**Susitna-Watana Hydroelectric Project**  
**(FERC No. 14241)**

**Response of the Alaska Energy Authority to  
Comments on the Initial Study Report**

Prepared for  
Alaska Energy Authority

October 2016

Figure 2.3.2-1. Bed elevation and change in 50 years for existing conditions

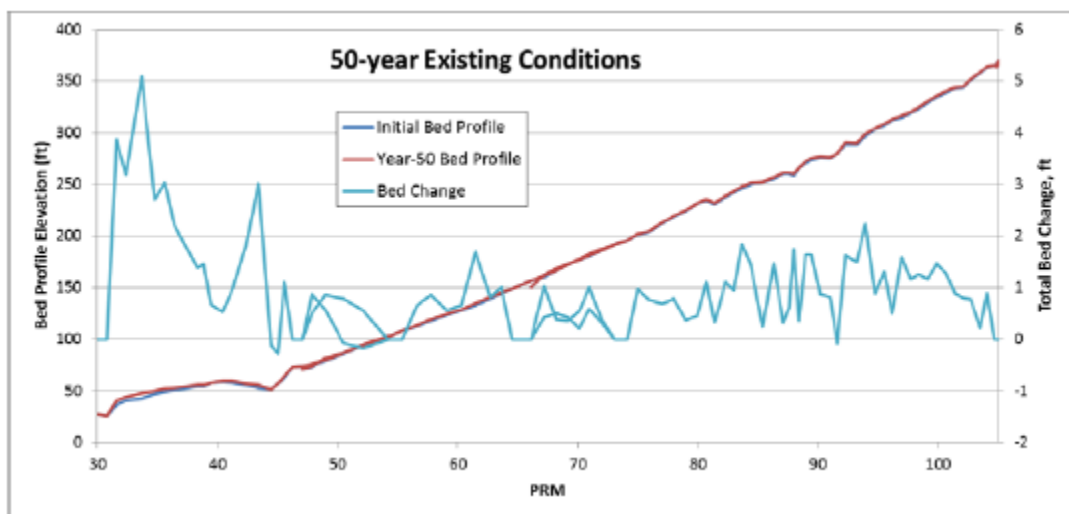
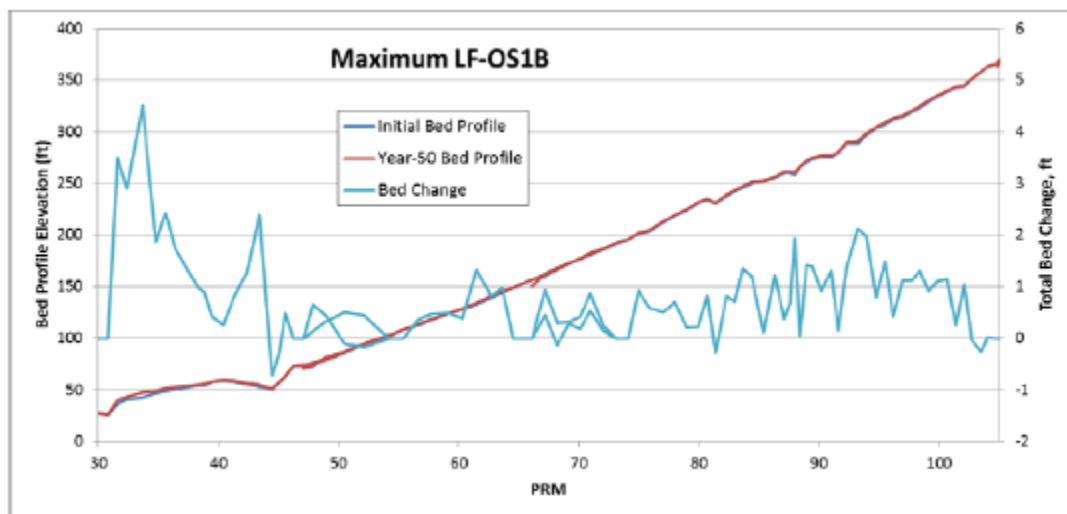
The comment appears to be indicating that aggradation in the downstream extent of the Lower River between PRM 29.9 and PRM 40 is physically unrealistic. AEA disagrees with that statement. The Yentna River contributes the largest amount of sediment to the Lower River immediately above the channel constriction at Susitna Station. The bed profiles shown in Figures 2.3.2-1 and 2.3.2-2 (below) show a 20 ft convexity, indicating significant deposition. The 50-year bed profiles are similar for each condition modeled. Other evidence that this is a depositional area is the extensive channel braiding in this area. Therefore, the model, bed profile, and planform provide consistent, expected, and physically realistic picture of the Lower River geomorphology.

AEA disagrees. This assertion is a misrepresentation or misinterpretation of the model results. As illustrated in the comparison of existing conditions with Max LF-OS1b, the Lower River modeling indicates that the entire Lower River is aggradational for both conditions. The *Decision Point TM* (Tetra Tech 2014c), which focuses on the Lower River, includes bed profiles and bed change for these conditions (Figure 2.3.2-1 for existing conditions and Figure 2.3.2-2 for Max LF-OS1b, as shown below). As discussed in the TM (Tetra Tech 2014c Section 5.3) and SIR (SIR 6.6 Section 6.2), the depositional nature of the Lower River is an expected condition because it has a strong bar/island braided planform (Tetra Tech 2015b Section 5.5). While the aggradation is concentrated in the lower area in both cases (above PRM 29.9), the impacts of the dam are actually minimal. The conclusion was that the Lower River is less aggradational under with-Project conditions.

Figure 2.6.2-1. Aquatic Restoration & Research Institute (ARRI) Middle Susitna River Chinook Salmon lengths from NMFS June 22, 2016 ISR Comments, Figure B3 in Appendix B.

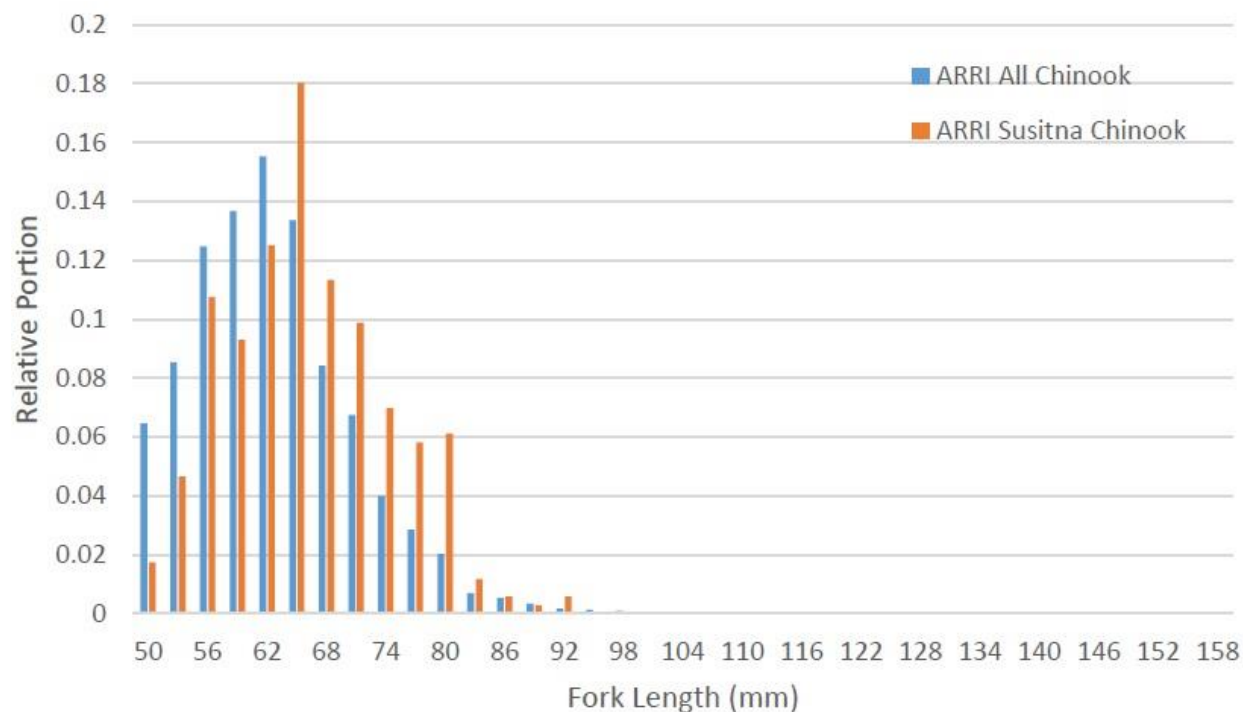
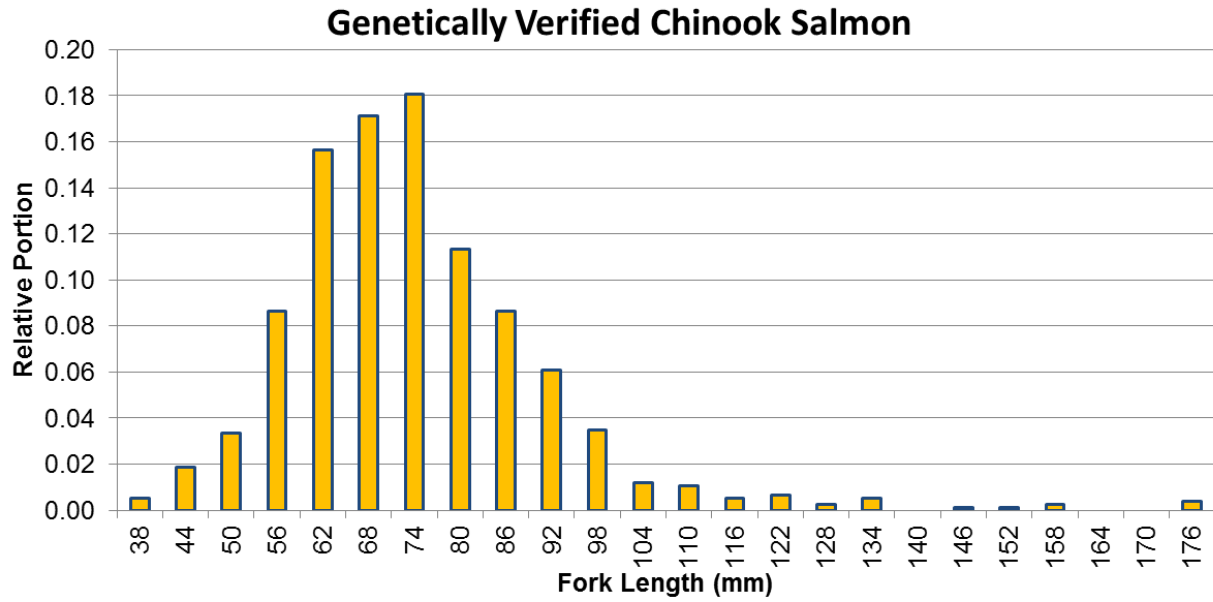
NMFS asserts that this is inconsistent with the size distribution of Chinook Salmon captured by the Aquatic Restoration and Research Institute (ARRI) (see Figure 2.6.2-1) and by ADF&G in the 1980s, with 99 percent of age-0 Chinook less than 100mm in fork length. NMFS comments that well over 50 percent of the fish reported by AEA as Chinook Salmon collected in the Middle River in 2013 are over 100 mm in fork length and are therefore, more likely to be age-2 Coho Salmon.

NMFS comments on species identification accuracy are based on length-frequency comparisons with a synoptic data collection using only minnow traps. NMFS states that the size distribution of Chinook Salmon identified genetically (Figure B-4 in SIR, Appendix B and Figure 2.6.2-2 below) is similar to fish collection by ARRI (Figure 2.6.2-1).

During 2013-2014 licensing efforts, 742 samples of genetically confirmed juvenile Chinook Salmon with length measurements recorded were collected ranging from 37-174 mm in length. The mean fork length of genetically confirmed Chinook Salmon was 71.7 mm and mean fork of all juvenile Chinook Salmon in the updated database is 61.3 mm (<http://gis.suhydro.org/SIR/09-Fish and Aquatics/9.6-Fish Dist and Abund Mid Lower Susitna/>). Consistent with other studies, 8.3 percent of fish genetically identified Chinook Salmon were larger than 93 mm, and 2.9 percent were larger than 110 mm (Figure 2.6.2-1). In summary, AEA’s Chinook Salmon length-frequency data set (including the SIR database updated with genetics results) and documentation of a two-year freshwater life history for around five percent of juvenile Chinook Salmon is consistent with the literature we reviewed, but inconsistent with ARRI’s minnow trapping data set. Because our data set is supported with genetics and similar to other research using multiple gear types on Cook Inlet Rivers, AEA maintains that NMFS’s comment mischaracterizes the quality of the data.

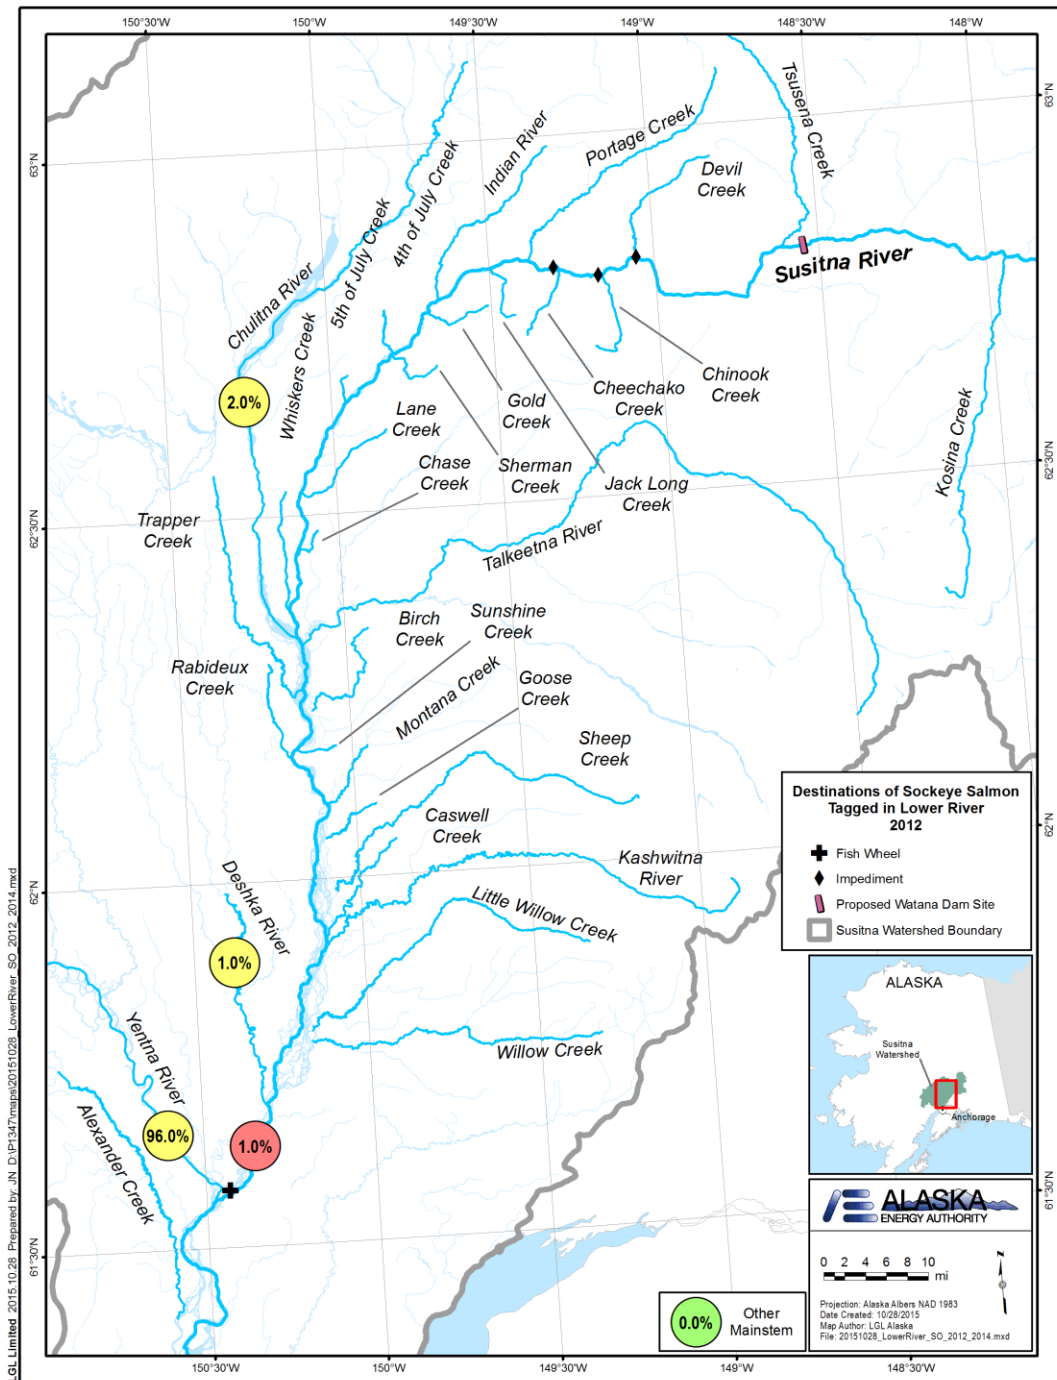
From NMFS's comments, which are incorrect at times, it is unclear why NMFS concludes that they disagree with AEA's *interpretation* of the data. For example, NMFS asserts that Figure D-9 from the SCR "*only shows tagged Sockeye Salmon destined for the Yentna*". Consistent with the results presented in Study 9.7 SCR Section 6.5.4, Figure D-9, (inserted below as Figure 2.6.3-3), show 96 percent of fish tagged and released in the Lower River had final destinations in the Yentna, with the remaining 1 percent, 2 percent and 1 percent destination assigned to the Deshka, Chulitna and mainstem Susitna River. Clearly AEA has accurately represented that 1 percent of tagged Sockeye Salmon from the Lower River were destined to the mainstem. Furthermore, as stated in Study 9.7 SCR Section 6.5.4, this finding of very few mainstem spawning Sockeye Salmon is consistent with the findings in the 1980s that found no Sockeye Salmon spawning in the Lower River.

In addition, NMFS suggests that not that attempting to determine the distribution of salmon into the Yentna River drainage or the Deshka River from tagging locations 22 miles upstream is evidence that current studies are not precise enough to confirm spawning areas in the lower Middle River (NMFS\_pp9.7-7\_ph3). This statement is fallacious. The spawning distribution of salmon in tributaries downstream from the middle river was never an objective of this study. The spawning distribution of salmon in the Yentna and Deshka has no relevance to identification of spawning areas in the lower Middle River.
